Re: PERCOLATION TEST RESULTS
Receipt # - A530296
6636 Cedar Lane (Aastoria II Assisted Living)

Re: **6636 Cedar Lane**
Percolation Certification Plan
#A530296

6636 CEDAR LANE

PERCOLATION CERTIFICATION PLAN

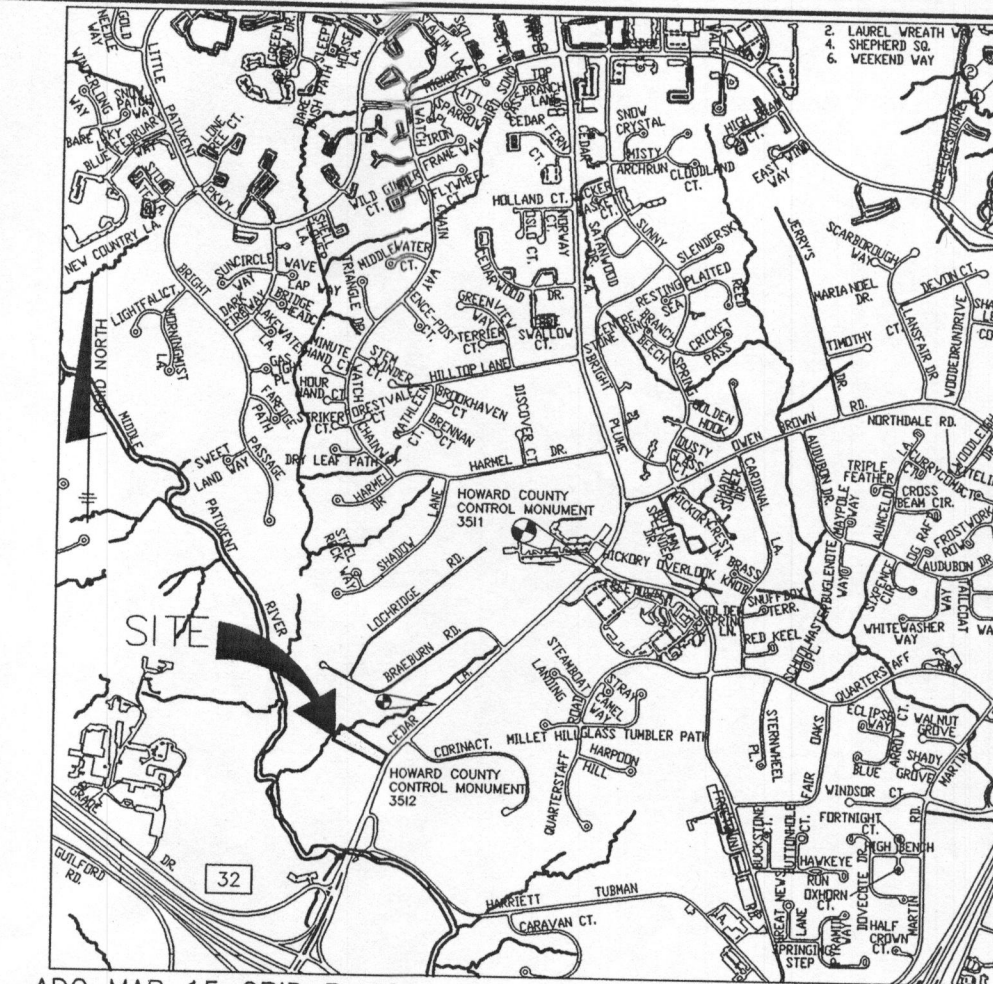
1. Test hole #4 has been removed as it was not tested.
2. General note #4 has been revised to reflect that the filed topography was verified by Benchmark Engineering, Inc.
3. The SRA has been revised as requested. It was necessary for us to extend the SRA to within 5 feet of the common property line of the subject property and lands owned by Hazel Wise. A revised variance request letter is attached.
4. General note #11 has been added to address the possible need for a low pressure dose system.
5. Minimum spacing calculations have been included in the tables for each cell.
6. The revised variance is attached.
7. The need for a future pump tank has been included as general note #12 and is also included in the variance letter.

<u>Comment No.</u>	<u>Response</u>
1.	The SRA has been revised as requested. It was necessary for us to extend the SRA to within 5 feet of the common property line of the subject property and lands owned by Howard County. A variance request letter is attached.
2.	We have applied the application rate as requested. It was necessary for us to modify the trench width and effective sidewall calculations in order to provide adequate treatment. We did this in accordance with Howard County Private Sewage Disposal Code section 16.9.1.
3.	The design of the trenches has been adjusted to have a width of 3 feet and an effective depth of 2 feet. This, along with the application rate, resulted in 417' of required trench per system. We have shown a tank layout that will require pumping in order to get the effluent to the third system.
4.	The tank detail should be provided with the building permit.

1. General note #6 has been revised as requested.
2. General note #9 was added to address the need for repair before building permit issuance.
3. The existing septic tank is no longer going to be utilized in the final design.
4. The 0.8 application rate has been included in the calculation for the absorption area.
5. The side wall absorption has been changed to 2.5 feet in calculations for the absorption area.
6. The septic area has been modified to be 20' from the retaining wall. There are vertical constraints that may limit the use of this area.
